DEPARTMENT OF TRANSPORTATION

49 CFR Part 571

Federal Motor Vehicle Safety Standards; Platform Lifts for Motor Vehicles; Platform Lift Installations in Motor Vehicles

ACTION: Notice of proposed rulemaking (NPRM); grant in part, denial in part of petitions for rulemaking.

FIGURE 2

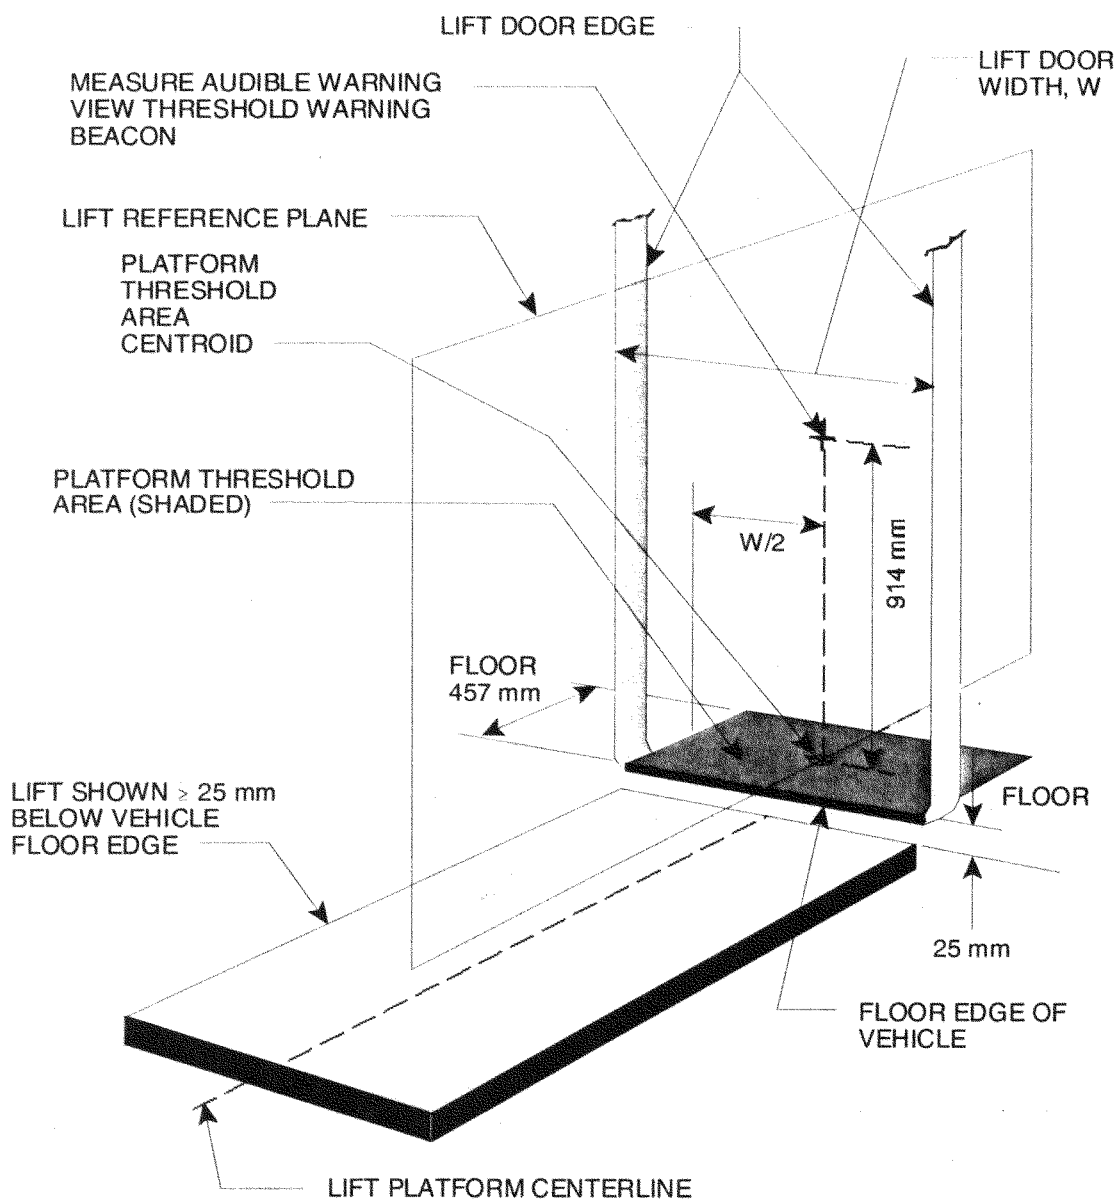
B. Correct Figure 2 in FMVSS No. 403 To Make it Consistent With the Threshold Beacon Warning Requirements in S6.1.6

It has come to NHTSA’s attention that a dimension in Figure 2 is incorrect. The height of the measurement point from which the intensity of the threshold audible warning is measured and the threshold warning beacon must be visible is identified as 919 mm. Because S6.1.6 provides that this measurement point is 914 mm (3 feet), we are proposing to replace Figure 2 with revised Figure 2, which shows a measurement point of 914 mm (3 feet), consistent with the requirements of S6.1.6.

S6.1.6 The intensity of the audible warning and visibility of the visual warning required by S6.1.2 and S6.1.3 is measured/observed at a location 914 mm (3 ft) above the center of the platform threshold area. (See Figure 2).
